AUTHORIZATION TO PROCEED WITH PLANT OPERATION TO STARTUP OPERATIONAL MODE 2 (CRYSTAL RIVER UNIT 3 NUCLEAR GENERATING PLANT)

ISSUANCE OF AMENDMENT NO. 1 TO FACILITY OPERATING LICENSE NO. DPK-72
FOR CRYSTAL RIVER UNIT 3 NUCLEAR GENERATING PLANT

CRYSTAL RIVER UNIT 3 NUCLEAR GENERATING PLANT

Amendment NO. 1

Figure 3.1-1
Regulating Rod Group Insertion Limits for 4 Pump Operation up to
Control Rod Interchange 250 ± 10 EFPD

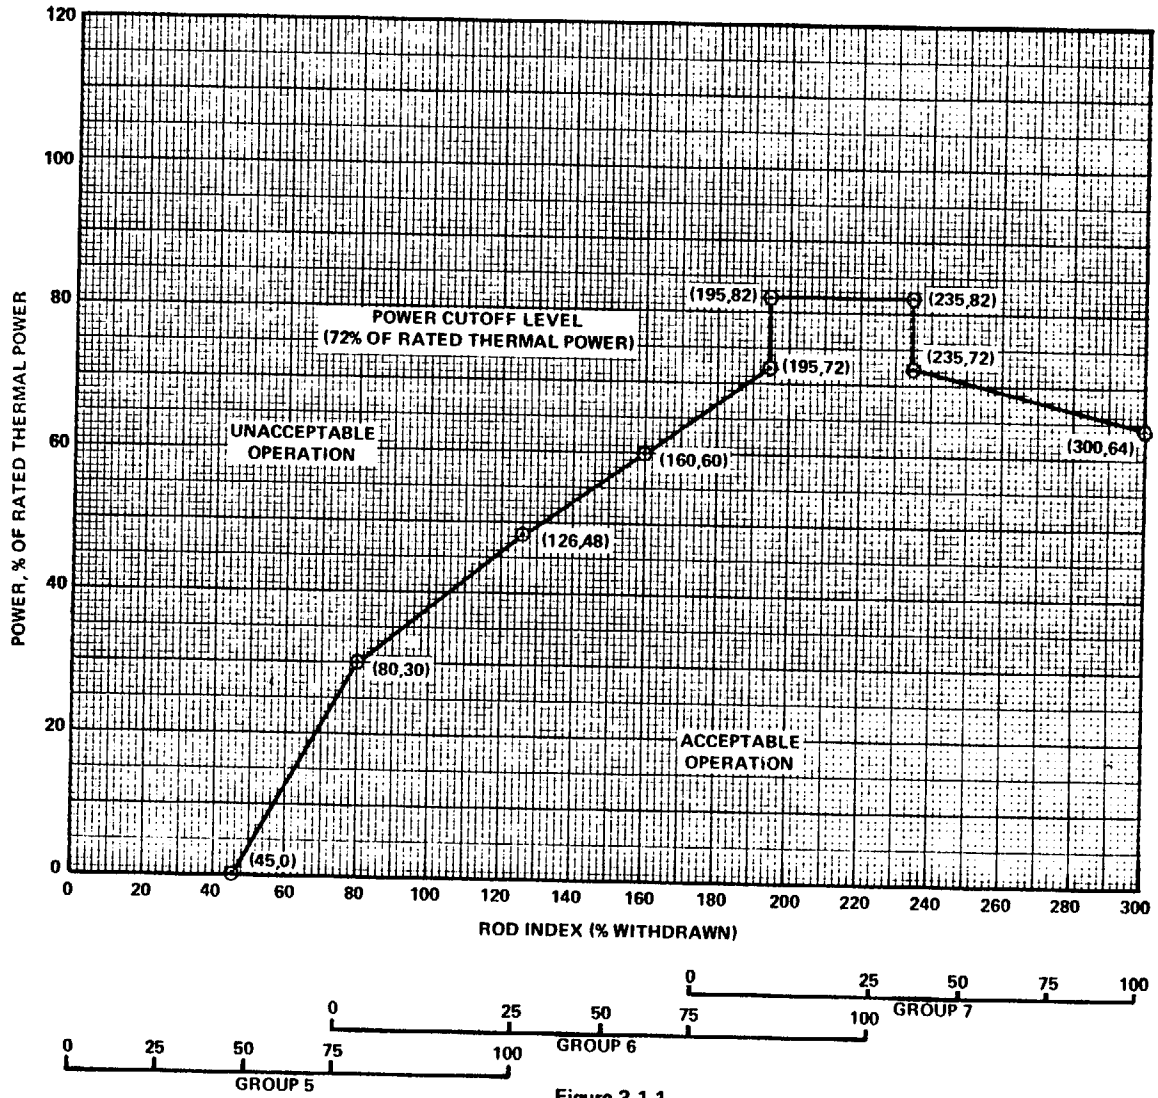
C. PRIOR to exceeding the regulating rod group insertion limits for 4 pump operation and axial power imbalance as specified in Figures 3.1-1 and 3.2-1 of the Technical Specifications as revised by Amendment No. 1, the following items shall be completed:

Replace the following pages of the Appendix "A" Technical Specifications with the enclosed pages. The revised pages are identified by Amendment number and contain vertical lines indicating the area of change. The corresponding overleaf pages are also provided to maintain document completeness.
